ENGINE - FUEL AND CONTROL - FUEL SYSTEM AIR TUBES - RE-POSITIONED CLIPPING POINT -
CATEGORY CODE 6 - MOD.ENG-73-0064

V2500-ENG-73-0064

- (1) Internal Reference No.
EC94VR027

Schematic view of clipping configuration of air tubes - Before alteration
Fig.1

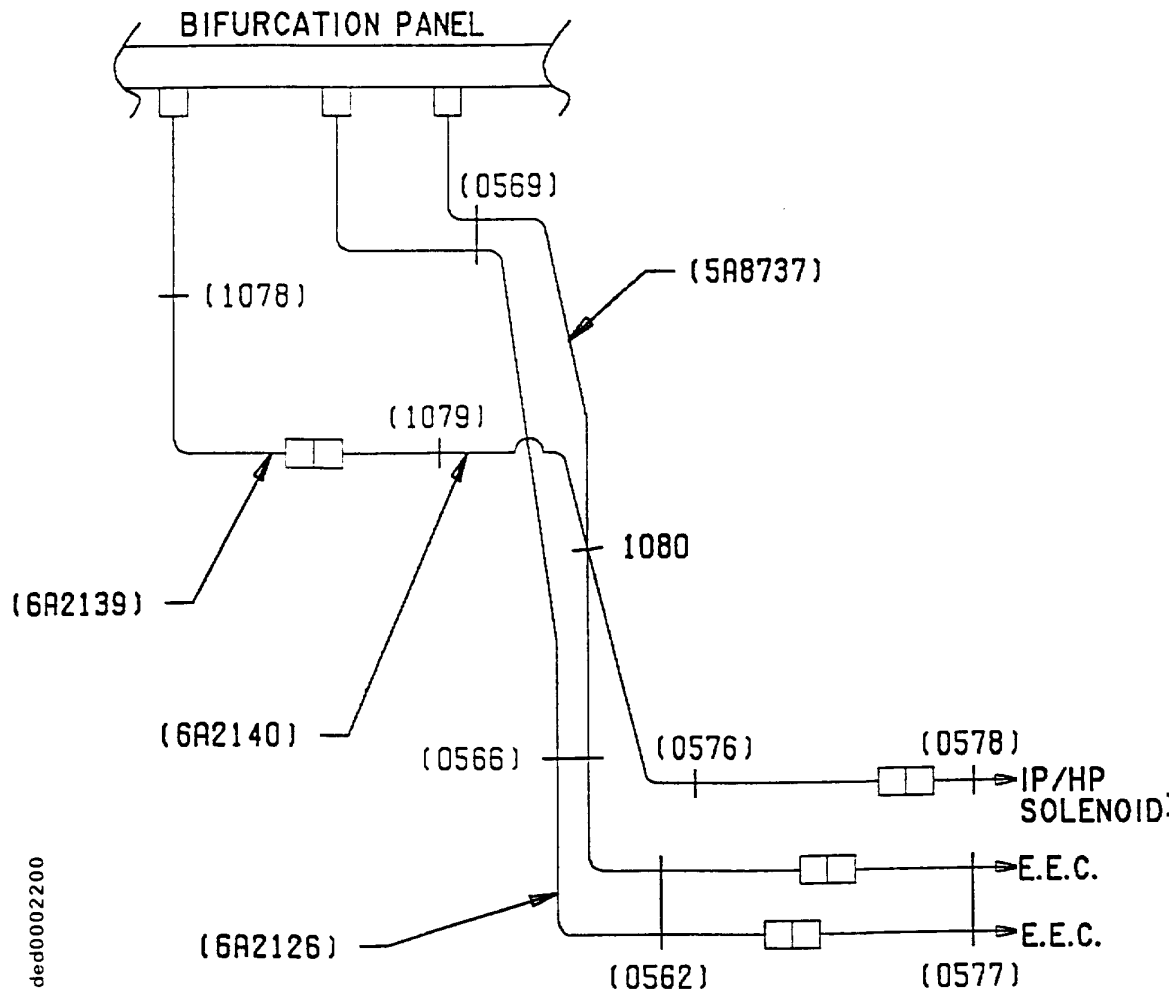
- (a) The length of the bolt at clipping point CP1080 has been shortened. In addition the clipping point CP1080, has been moved approximately 0.5in. along the over-ride air tube of the Stage 10 bleed valve. The clipping point is attached to the P2.5 not the P4.9 air-tube assembly.

- (1) Replace the bolt of CP1080 (Refer to Figures 1 and 3)
 - (a) Remove the clip point from tubes 5A8737 and 6A2140
 - (b) Discard the bolt 4W0104.
- (2) Install CP1080 in a different position (Refer to Figures 2 and 3)
 - (a) Install the top clip of CP1080 to tube 6A2126
 - (b) Install the bottom clip of CP1080 to tube 6A2140
 - (c) Safety CP1080 with the bolt 4W0103, washers and nut.
